Environmental Overview in Support of Petition for Changed Conditions

CPV Towantic Energy Center

October 2014

CPV Towantic, LLC

Figure 3.
Revised CPV Towantic Energy Center Elevation Drawing

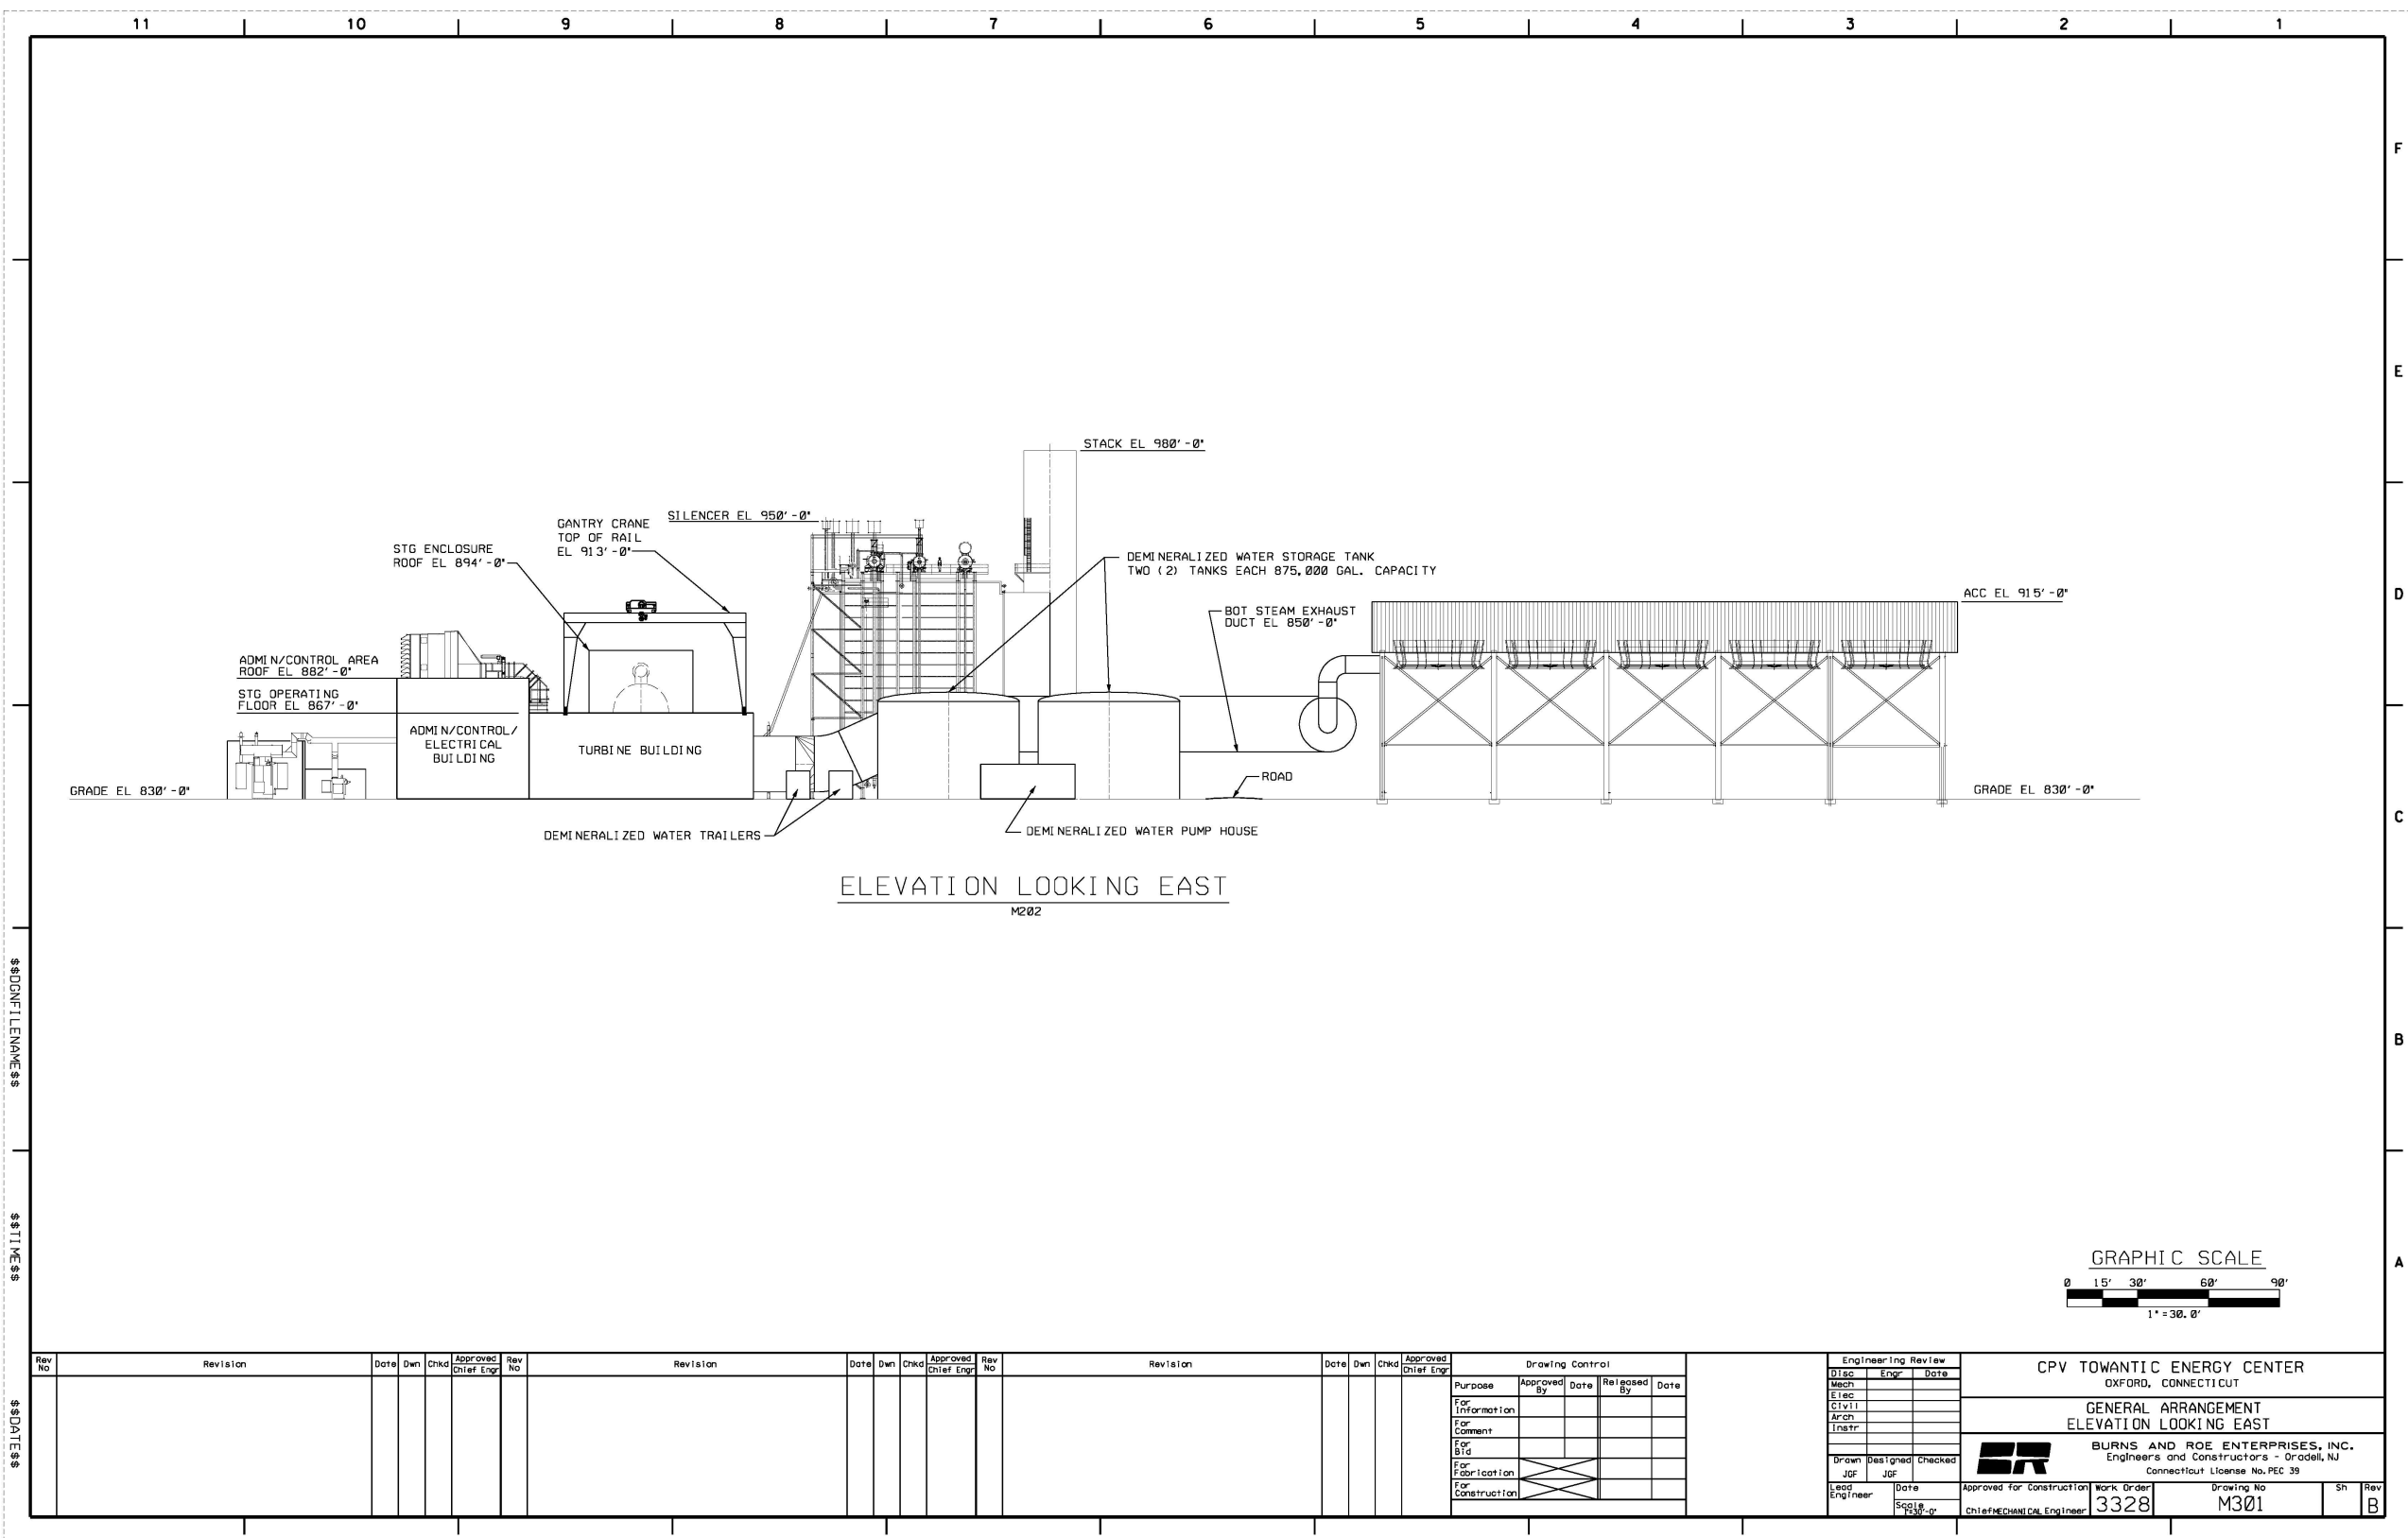
The updated GE technology and associated equipment results in certain structure height adjustments inherent in the technology. In addition, layout features were evaluated to determine if they reflected the most benefit for the updated Project, including several changes that could be made to result in more favorable visual and/or dispersion modeling effect. This resulted in certain minor structure height changes, as reflected in Figures 3 and 4:

- The building enclosure design inherent in GE's updated H technology allows for the elimination of a large 110-foot tall over-building for the combustion turbines. Much of that building enclosure consisted of open area for crane movement during outage periods. By eliminating the large structure, and incorporating three separate, smaller and shorter building enclosures (one for the steam turbine that is 64 feet tall and one for each of the combustion turbines that are 37 feet tall) and a crane rack, the Project visibility can be greatly reduced.

Figure 6.
Proposed Site Grading and Stormwater Management Features

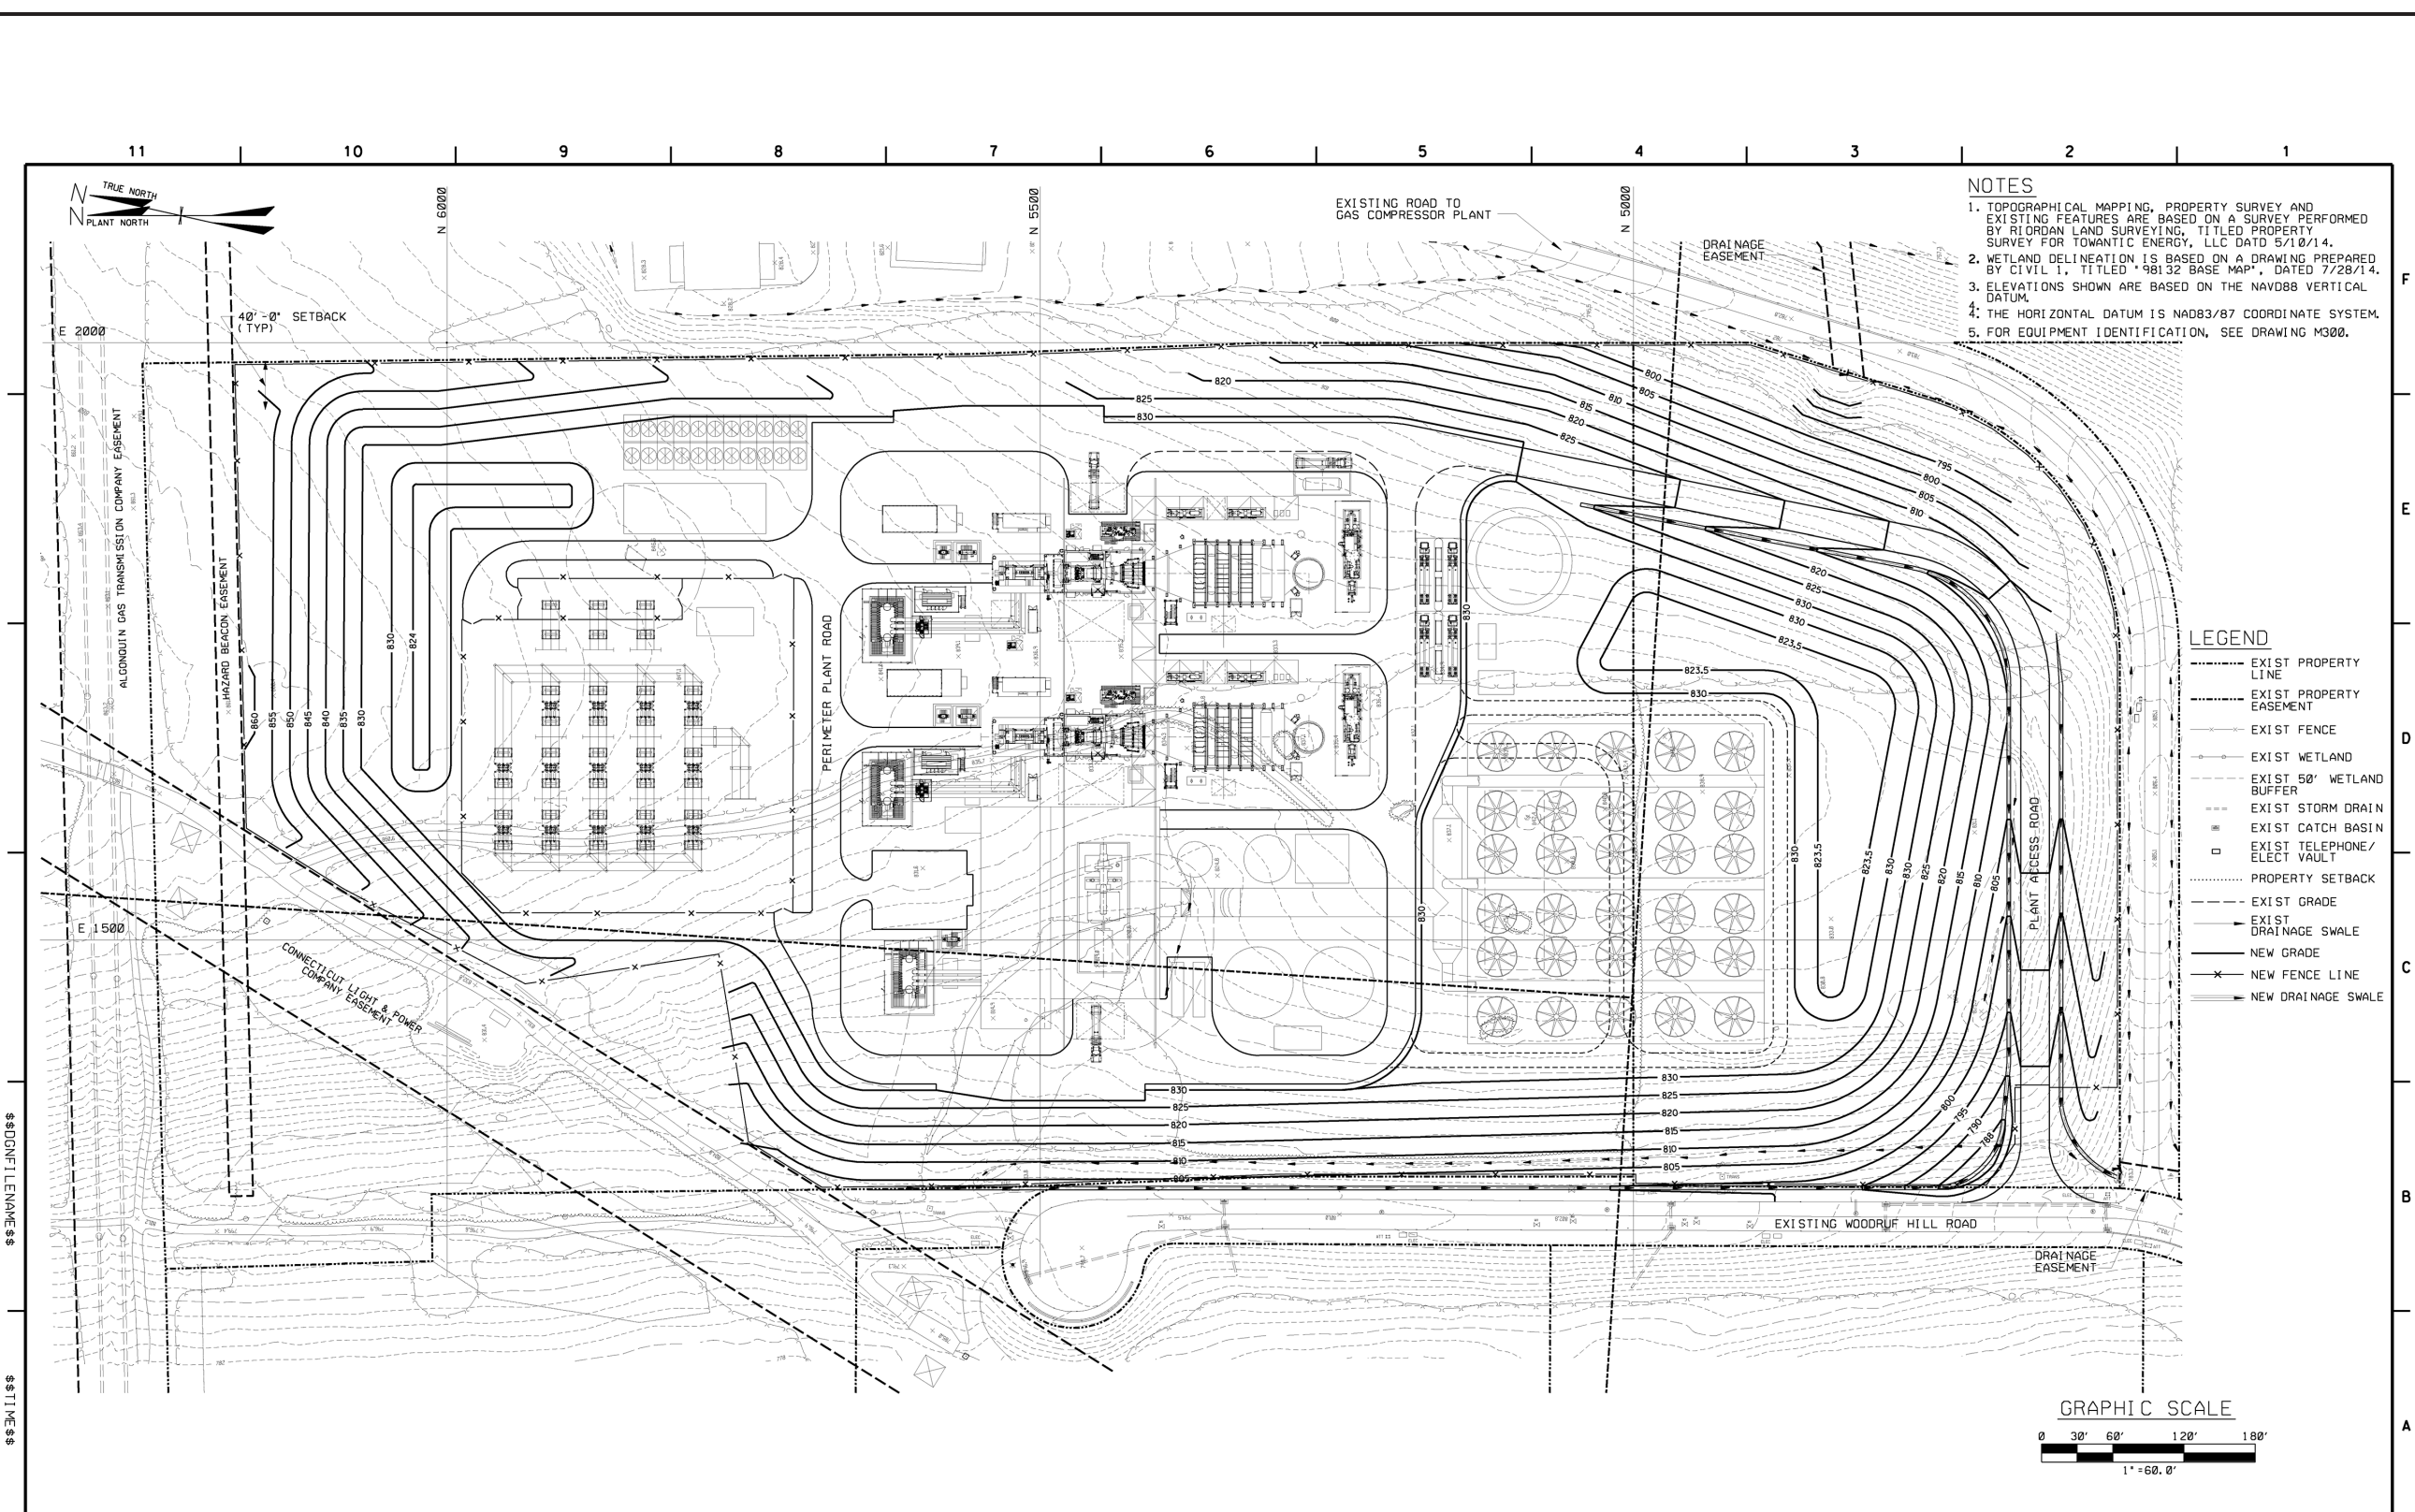
Figure 6 illustrates proposed grading and stormwater management features proposed for the Project. The addition of the 6-acre parcel to the south of the site allows for moving the stormwater detention pond from under the ACC, which was not recommended by the ACC vendor, while still maintaining performance guarantees and more importantly meeting state requirements as outlined in the 2004 Connecticut Stormwater Quality Manual (2004 Manual).

The original arrangement included a dry detention pond at the southern site boundary that would meet the stormwater needs of the developed portion of the site. Due to spatial constraints, the pond was located below the elevated ACC unit, which is not optimal for its function. Drainage from undisturbed areas in the northeast portion of the property was to be directed to the original drainage paths east of the property. Drainage from undisturbed areas in the northwest and west portion of the property was to be directed to the planned compensating wetland area. Grass and crushed stone were used in the undeveloped portions of the property to facilitate infiltration and groundwater recharge. Under this design scenario, a number of elements of the 2004 Manual would not have been met, including groundwater recharge requirements for the pond and applicable setback distances from slopes and structures. Relief had been requested from the state, and best available design measures incorporated to meet the intent of the 2004 Manual to the greatest extent possible.

The larger area now available for the Project allows for two detention ponds, repositioned away from structures and reflecting the existing sub-watershed drainage, as well as incorporation of a design reflecting Low Impact Development Principles and the most recent Connecticut stormwater standards. Under the proposed Project configuration, all requirements of the 2004 Manual will be met. Additional stormwater design information is included as a component of the USACE application, discussed in the following section.
